EPEE and Eurovent would like to thank you for giving us the opportunity to provide comments on the Working Documents on air heating products, cooling products and high temperature process chillers (Ecodesign ENTR Lot 6/ENER Lot 21 and parts of ENTR Lot 1).

EPEE and Eurovent Position on the working documents on requirements for air heating products, cooling products and high temperature process chillers

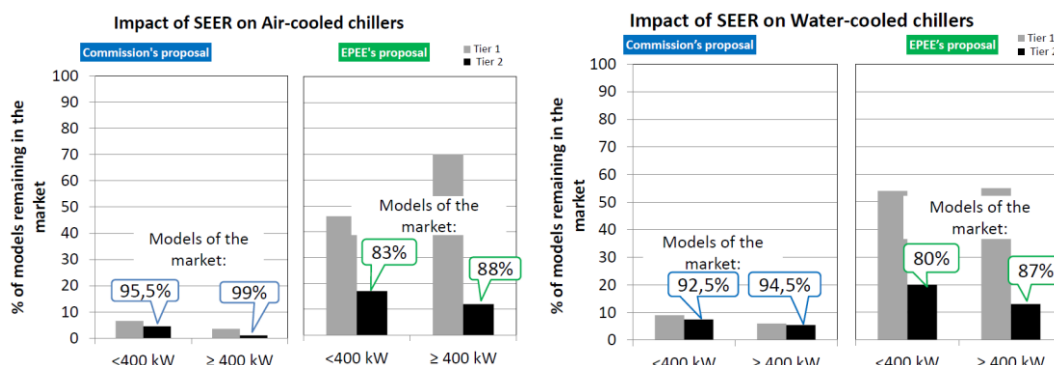
- Moreover, the proposed requirements need to balance differences in the operation chillers in cooling and heating systems. Due to the reversibility of some chillers, improving the cooling function does not necessarily result in improving the heating function and vice versa. Since the heating requirements have been decided under another Ecodesign implementing

measure, the cooling requirements should take these into account in order to allow for a feasible balancing of cooling and heating efficiency.

- Regarding the timing, EPEE considers that the proposal to introduce different implementation timeframes for Lot 1 ((EU) No 813/2013) and Lot 6/Lot 21 creates complexity and provides industry with too many different targets to achieve.

- For chillers above 400kW, the proposed requirements as they currently stand are not technology neutral, as they strongly promote oil free technologies. Therefore, we propose lowering the SEER values and introducing an additional capacity class starting from 1,5 MW.

3.1 Limiting sound power will also limit efficiency

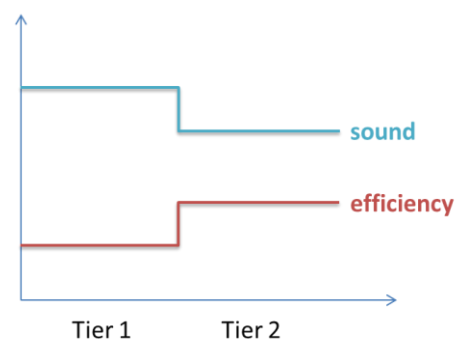
The main causes of sound emissions are the operation of the fans and the compressors. In order to decrease sound power, the fan speed needs to be reduced or fans need to be redesigned. As a result, the air flow over the heat exchangers decreases, and as such the efficiency decreases too.

Therefore, by defining sound power requirements, the energy consumption would increase, and this goes against the objectives of Ecodesign.

Given the dependency between sound power and energy efficiency, it is not feasible to fulfil simultaneously the requirements of two tiers of improved energy efficiency and two tiers of lower sound power.

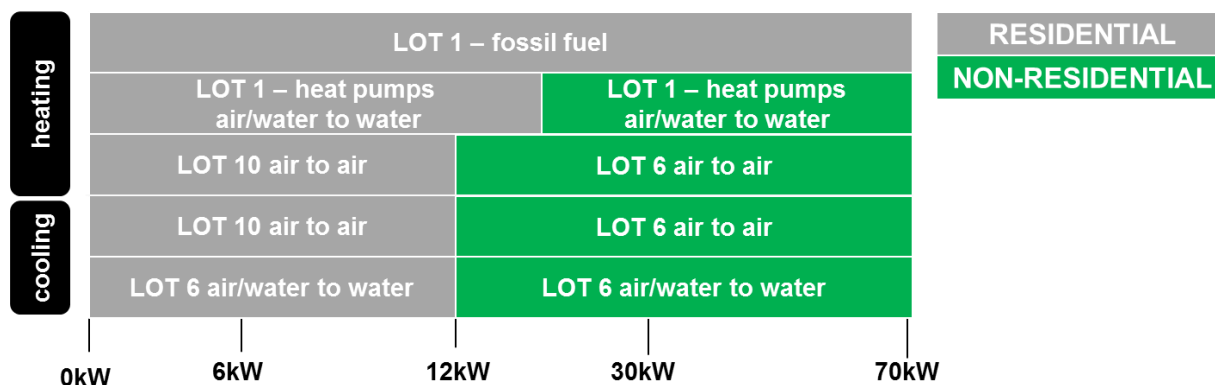
In our view, the sound power requirements for air-to-air air conditioners and heat pumps are based on the assumption that the outdoor units of the air-to-air air conditioners and heat pumps are the same as the outdoor units of the ENER Lot 1 products. In other words, the sound power requirements are based on the base case of the ENER Lot 1 products. Indeed some outdoor unit types of ENER Lot 1 have similar technologies, but do not necessarily possess the same sound power levels. ENTR Lot 6 base cases have higher energy efficiencies and sound powers than ENER Lot 1 products. More efficient products require higher air flows in the equipment, which consequently causes relatively more noise. Meeting the sound power requirements is therefore not feasible.

The rationale behind the introduction of sound power requirements in Lot 10 was to ensure that manufacturers would not improve their products in a cheap way in order to ensure sustainable solutions for increasing the efficiency of the product. In this lot, we deal with non-residential products, and consequently the dynamic for design is very different. The existing national legislation for sound emissions already limits the sound levels of the products. The best solution for sound requirements is selected by the building engineer for the site. Therefore, there is no room to improve the products in this application range without business impact.

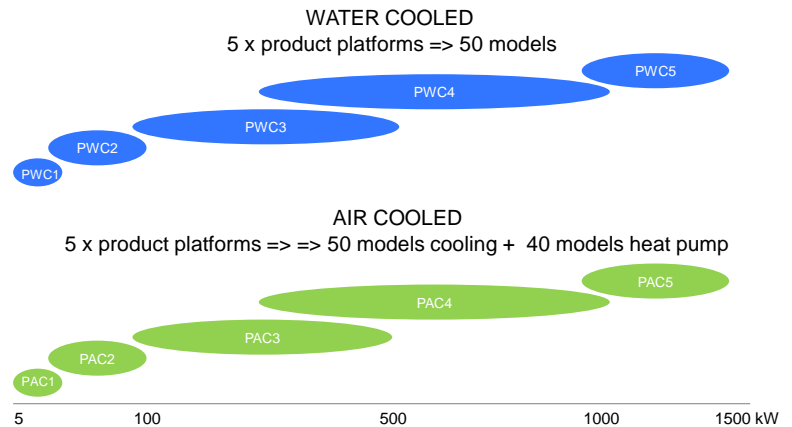
- o Larger heat transfer surface in the condensers is extremely expensive, making the cost prohibitive. In addition, it is often not possible because of space constraints: a large share of the market for such units is used to replace old units with a predefined foot print that cannot be changed. Also, these units must fit within standard containers for transportation, which puts an additional constraint on size.

For all these reasons, there is very little room for efficiency improvement in the future for this category of machines, already highly optimized. One possibility would be to use magnetic bearing centrifugal compressors. They can offer a better efficiency than screws at part load. But these machines are still quite expensive. Also, in the capacity range that is needed for this category of chillers, these compressors are offered by only one manufacturer. Setting MEPS targets that can be reached with this technology only would create a monopoly situation that is not acceptable.

As a conclusion, we believe that the best machines available today in this category (air cooled >400 kW) are already close to an optimum. It would be unrealistic to expect further substantial improvements in the mid-term future.

Note: Industry average product development cycles

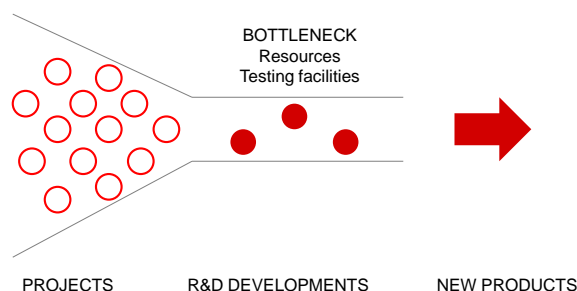
Chillers are complex systems using multiple compressors and smart control systems to optimize energy consumption. Most chillers are also available with many factory installed options to address special applications, ie: low sound emissions, heat recovery for sanitary hot water production, low leaving water temperature applications...etc which further increase the research development time. Depending on the complexity of the redesign (partial or full redesign) the overall development time goes from 18 to 30 months for a single product platform. More details are given in the graph here with.

TECHNOLOGY	DEVELOPMENT	PRODUCT LAUNCH MANUFACTURING	TOTAL
	Technology assessment Product concepts Supplier selection	Specifications Qualification Testing Reliability	Product literature Selection software Assembly line set up	
PARTIAL REDESIGN	3 months	12 months	3 months	~18 months
FULL REDESIGN	6 months	18 months	6 months	~30 months

In conclusion the industry needs a minimum of 4 years between Tier 1 and Tier 2 to redesign products
